Technical Note 3 – 2nd Response to National Highways

Project Name:	Fryatts Way, Bexhill	Office:	Manchester
Project No.:	784-A115791	Prepared by:	M Thompson
Date:	17.06.2022	Checked by:	M Thompson
Status:	For Information	Approved by:	L Regan

- 1.1 This Technical Note (TN3) has been produced to respond to the National Highways (NH) comments dated 21 March 2022 on Rother District Council (RDC) planning application reference RR/2021/1656/P.
- 1.2 The planning application package submitted included a Transport Assessment (TA) produced by Tetra Tech (Tt). A previous Technical Note (TN1) was submitted in response to NH comments dated 18 October 2021. Further comments were then received in March 2022, which are responded to within this Technical Note (TN3).
- 1.3 The planning application is for up to 210-dwellings on Land off Fryatts Way in Bexhill.
- 1.4 The NH comments are attached at **Appendix A**. Their comments cover:
- 1) Personal Injury Accident Review
 - 2) Committed Developments
 - 3) Trip rates
 - 4) Assessment Years
 - 5) Traffic Impact Assessment
- 1.5 Each of those matters are dealt with in sub-sections of this TN3.

Figures v2: Fig 24: Trip Generation (Sensitivity Test) - Proposed Residential Development - AM Peak Hour

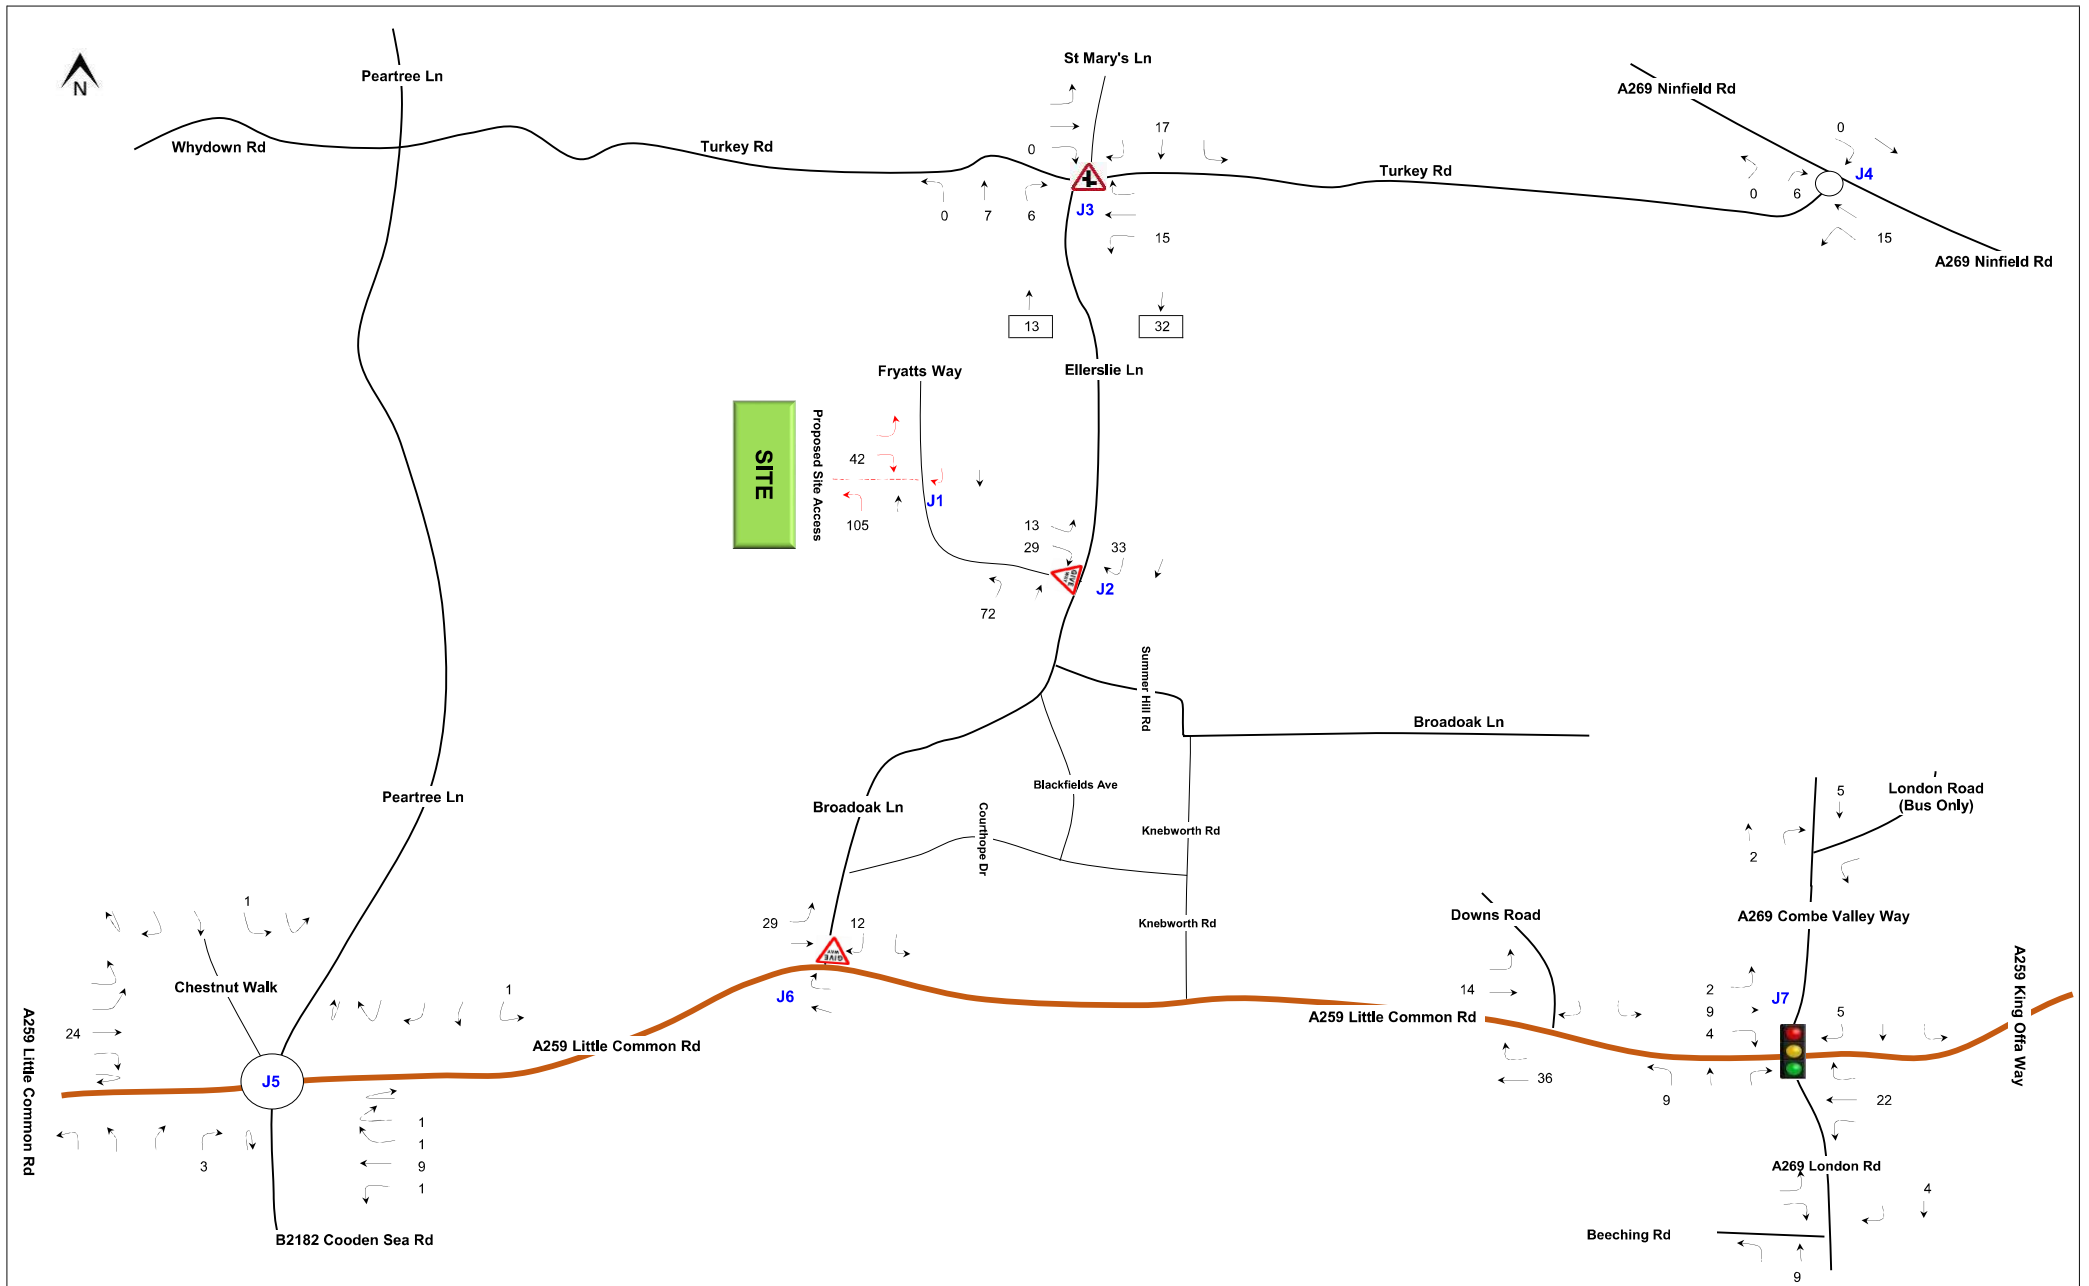
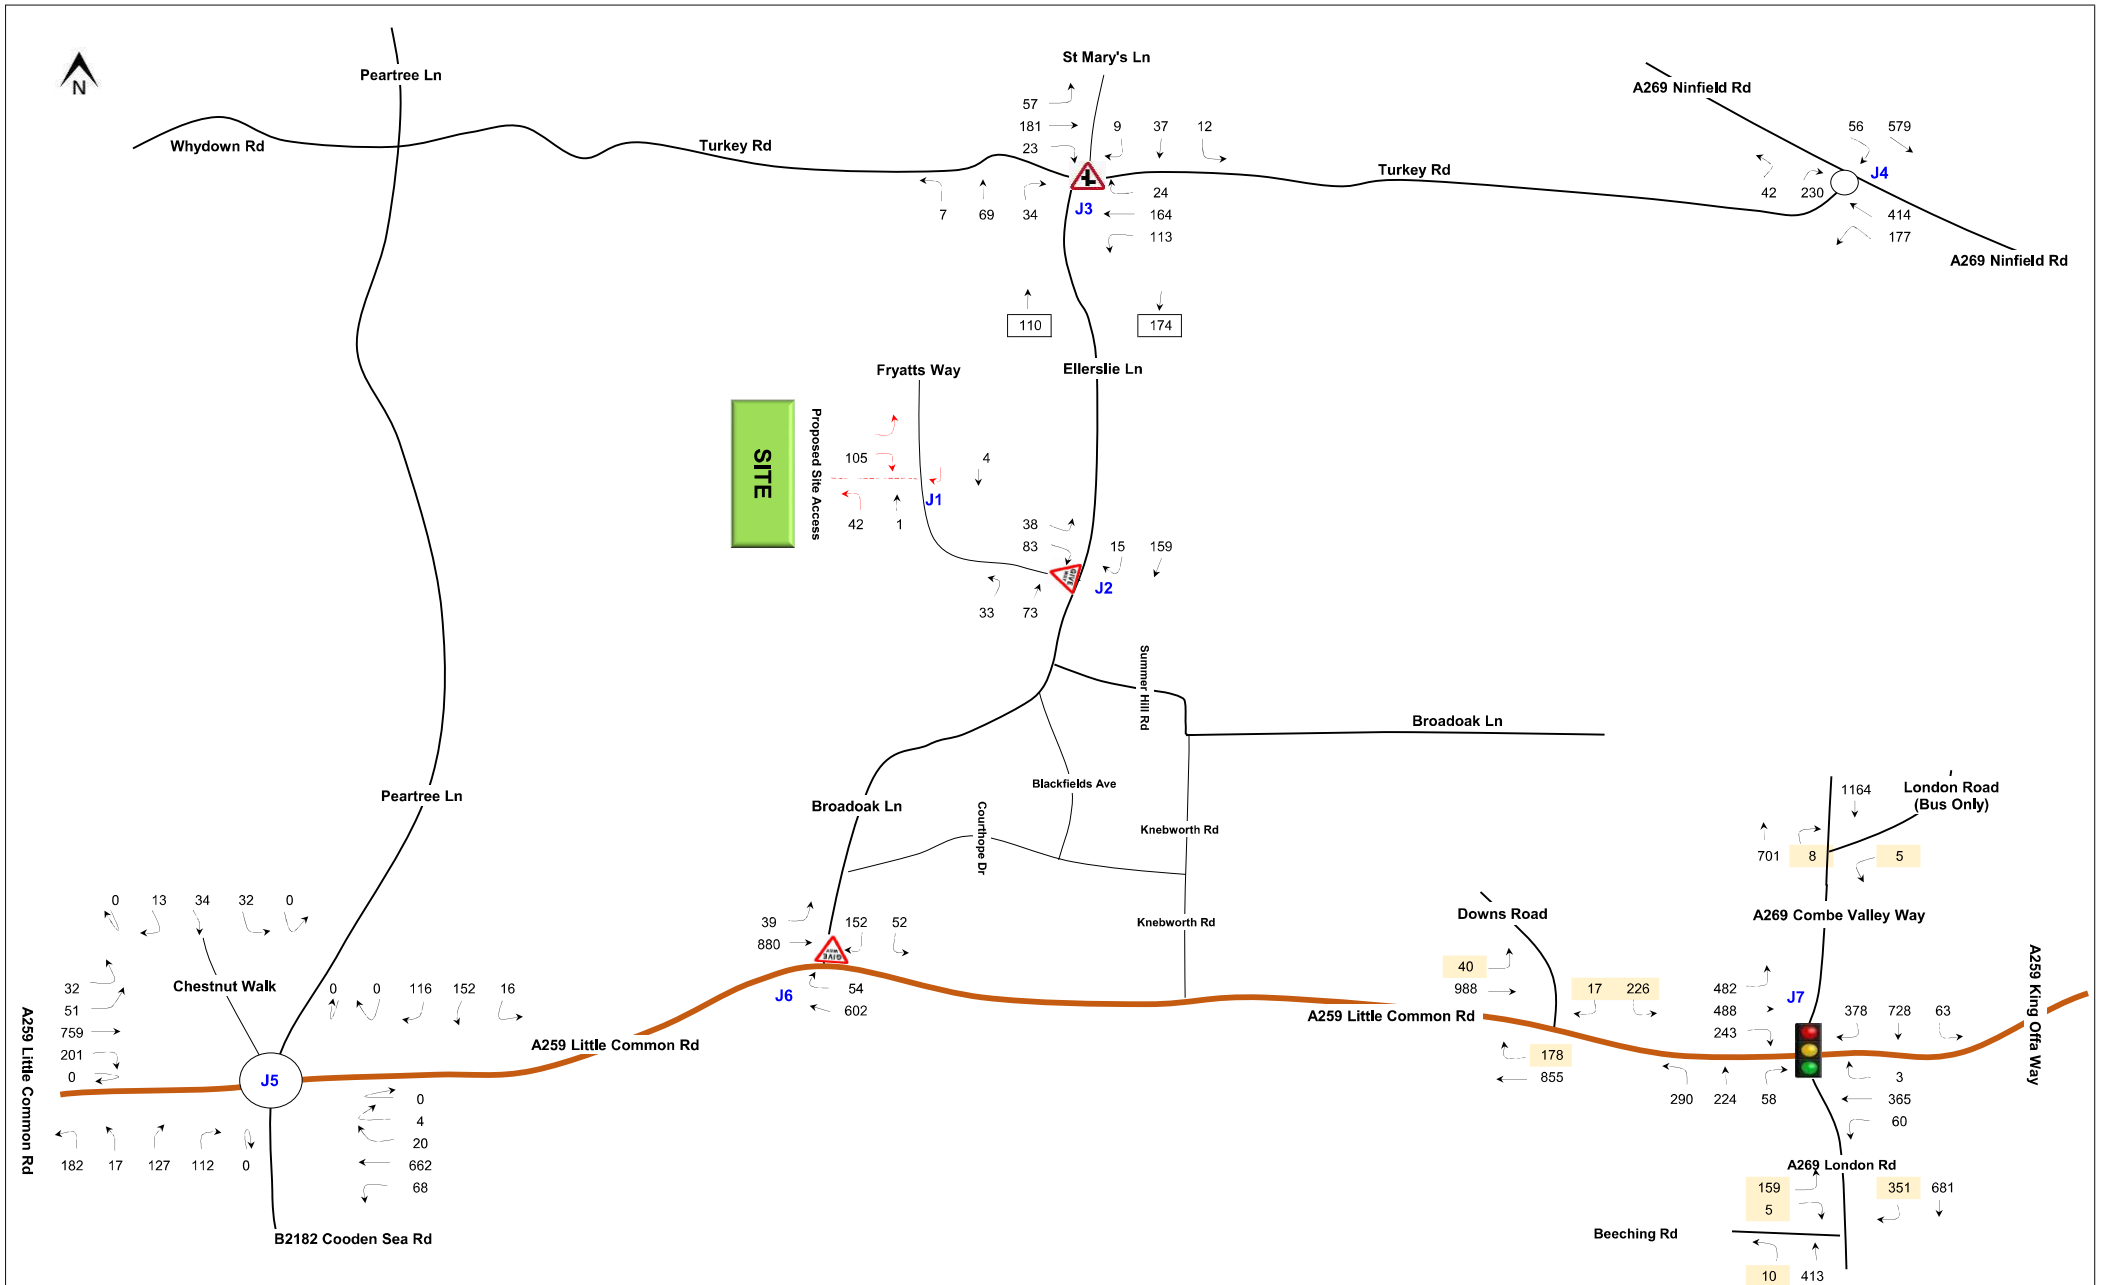
“We continue to wish to see a sensitivity test using a trip rate of 0.7 per dwelling in the AM and PM peaks.”

- 4.2 It is considered that there is no justification or policy requirement to support this request. It clearly presents impacts which are greater than can reasonably be expected.
- 4.3 There is evidence of a trend in trip rates reducing as described in TRICS Guidance Note on Changes in Travel Behaviour, August 2019 (see **Appendix D**) and that there are numerous cases of sites in similar settings where the Planning Inspectorate have accepted trip rates in the region of 0.5 to be appropriate.
- 4.4 However, as requested the sensitivity test has been undertaken in the traffic impact assessments set out in Section 7 of this TN.

7.6 NH have also requested a sensitivity test using 0.7 trip rates. The sensitivity test results are shown in **Table 7.2**.
